**51ST ROUNDABOUT
IMPROVEMENTS
FOR
ARLINGTON 51ST ST LLC**

**51ST AVE STORMWATER
BYPASS ADDENDUM
PLAN & PROFILE**

**1 OF 1
ADDM #1**

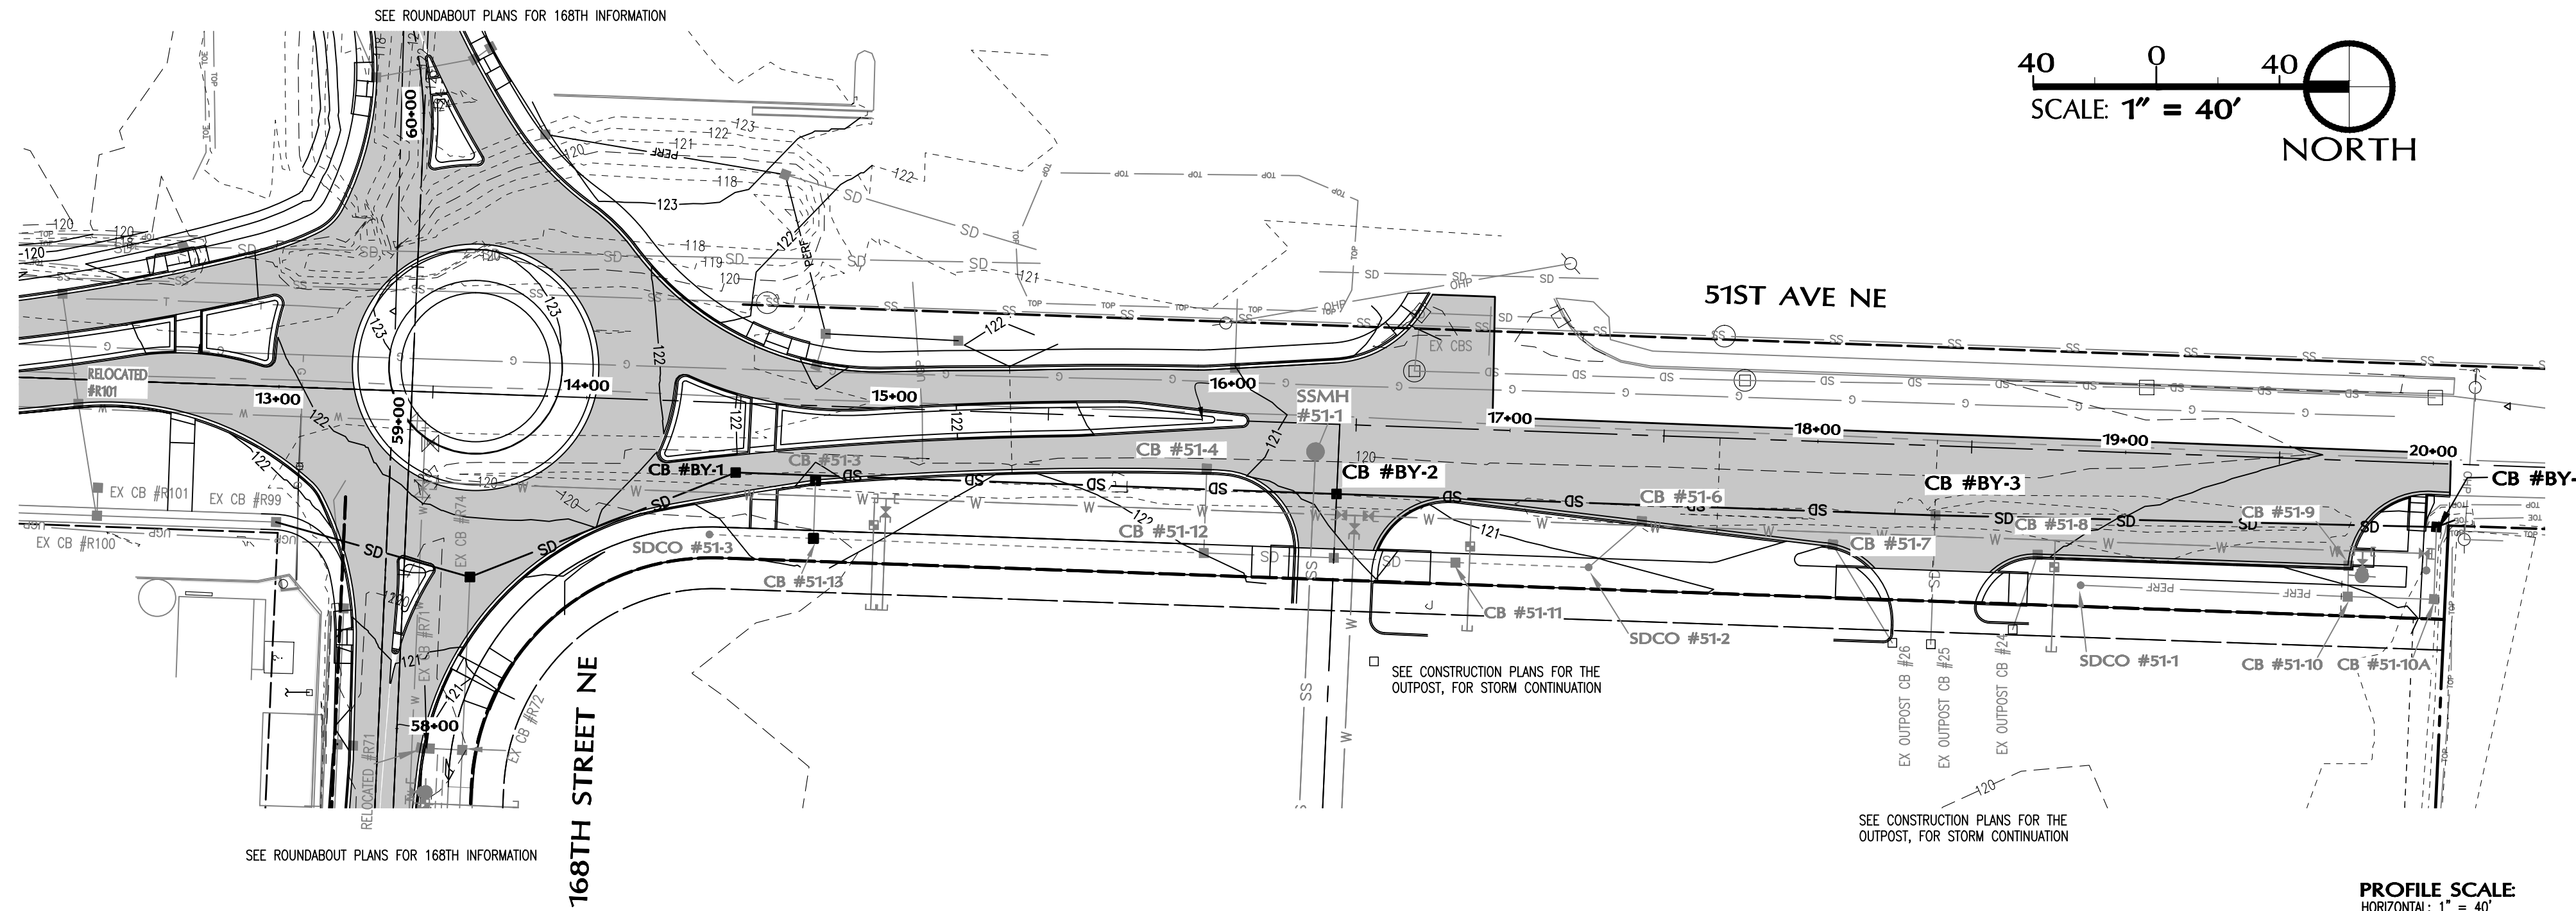
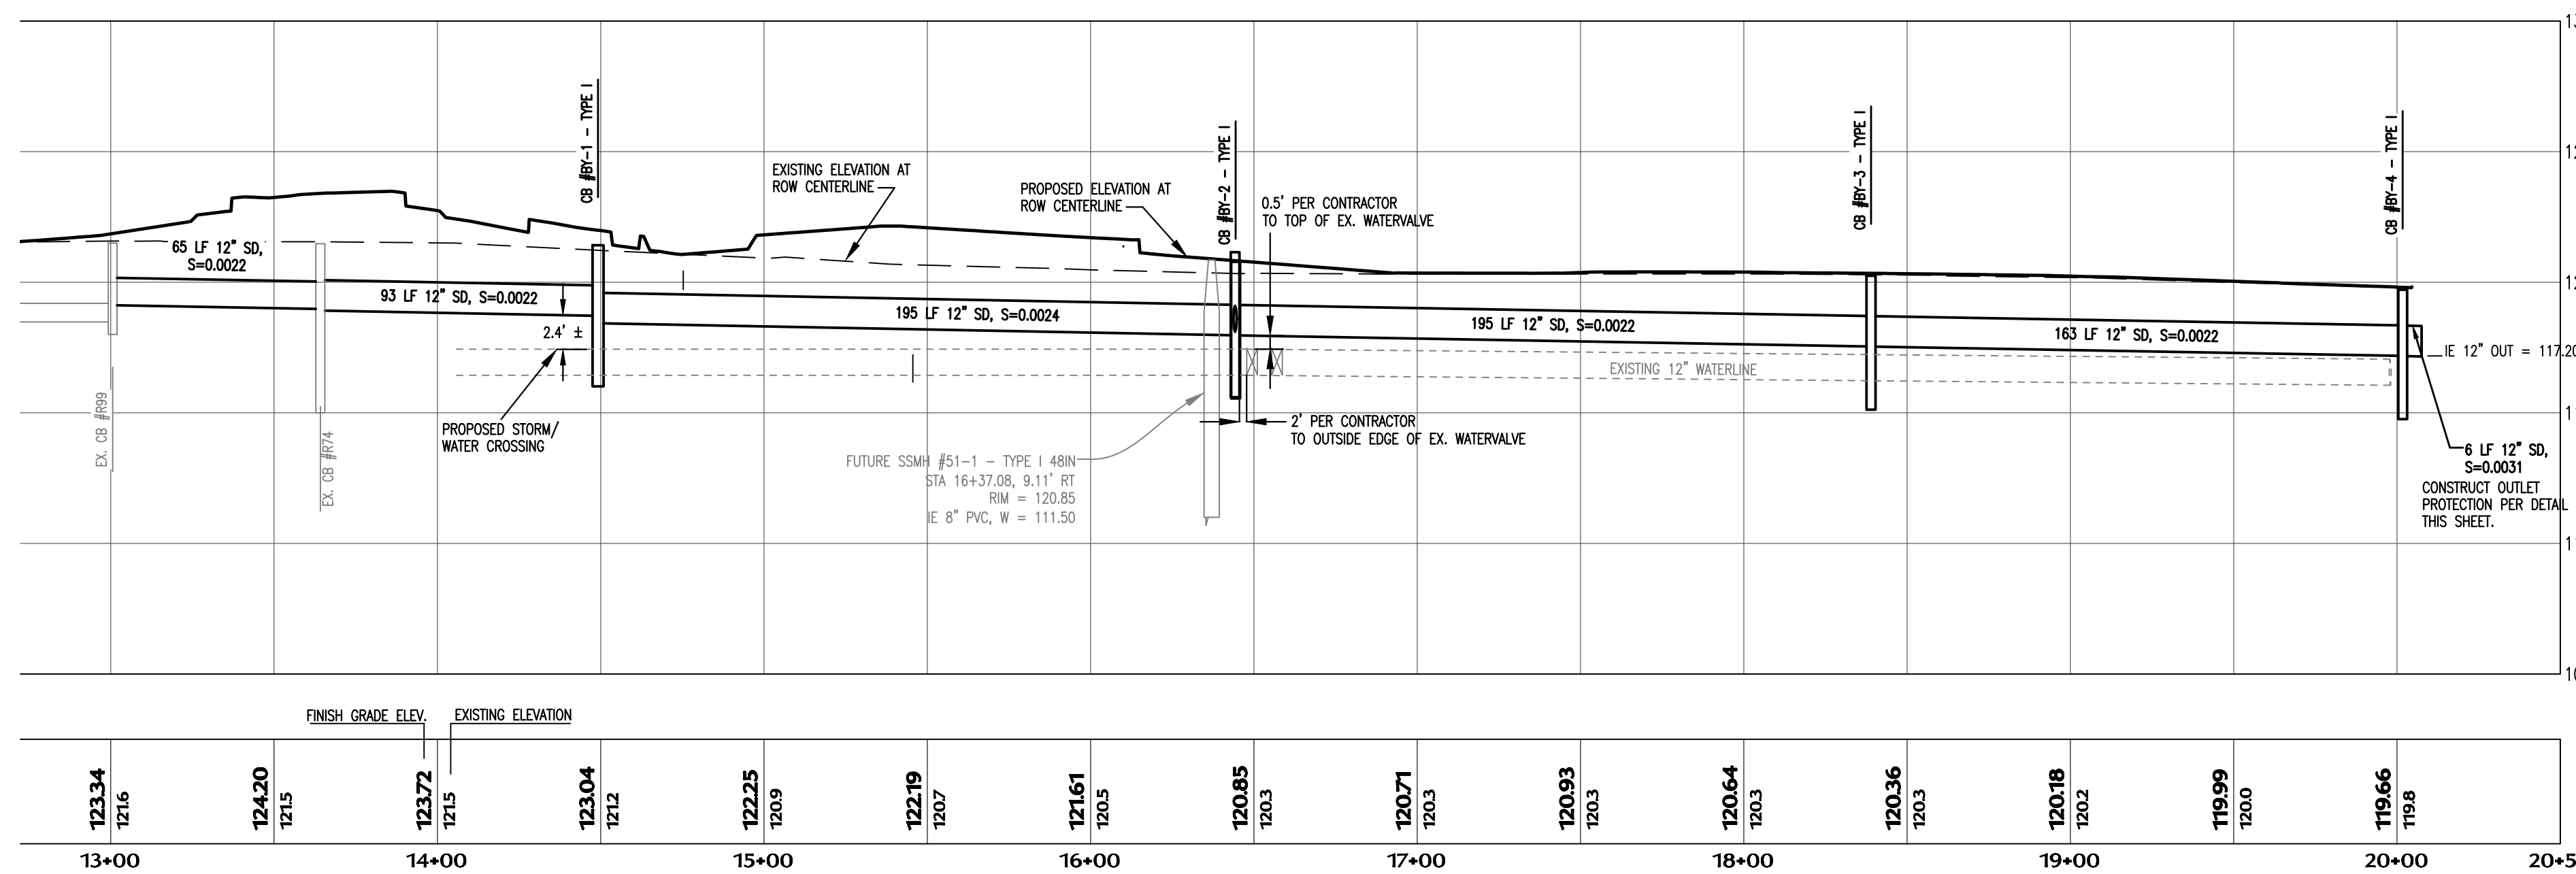
THIS SHEET IS AN ADDENDUM TO THE 51ST AVE AND 168TH STREET ROUNDABOUT DESIGN CIVIL PLANS. ALL SPECIFICATIONS AND DETAILS NOTED ON THOSE PLANS SHALL BE APPLIED AND INCORPORATED INTO THIS CONSTRUCTION. CONTRACTOR SHALL ACQUIRE THE DETAILS AND SPECIFICATIONS FROM THAT PLAN SET PRIOR TO CONSTRUCTION.

NO FURTHER ROUNDABOUT IMPROVEMENTS ARE TO BE CONSIDERED, BEYOND THIS SHEET, UNTIL SAID ROUNDABOUT CONSTRUCTION PLANS ARE APPROVED. NO CONNECTION POINTS TO CBS #BY-1 THRU BY-6 SHALL BE CONSTRUCTED FOR FUTURE 51ST STORMWATER DESIGN.

CONTRACTOR TO POTHOLE AND VERIFY EACH WATERLINE CROSSING PRIOR TO ANY STORMWATER LINE WORK. LOCATION AND ELEVATIONS SHALL BE PROVIDED TO ENGINEER UPON DISCOVERY.
